Without Prejudice Conditions of Consent – X/1436/2021

Note – These draft deferred commencement matters and draft conditions of consent have been prepared on a without prejudice basis should the Panel disagree with the recommendation of Council staff.

DEFERRED COMENCEMENT MATTERS (WITHOUT PREJUDICE)

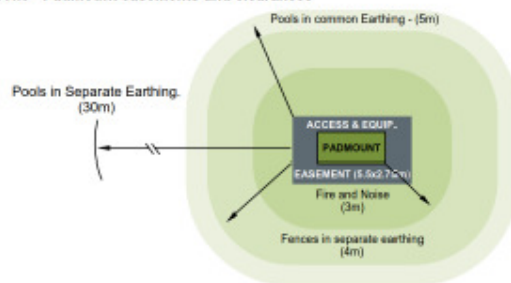
The following extracts of the Architectural Plans show the provision for a padmount substation to the south western Wascoe Street road frontage (which is shown in the below extract of Google Maps Street View).

From Endeavour Energy's perspective the fact that provision is being made for a padmount substation is a positive (which may facilitate the removal of pole mounted substation no. 9360). Endeavour Energy's general requirements is for a padmount substation to be at ground level and have direct access from a public street (unless provided with appropriate easements for the associated underground cables and right of access).
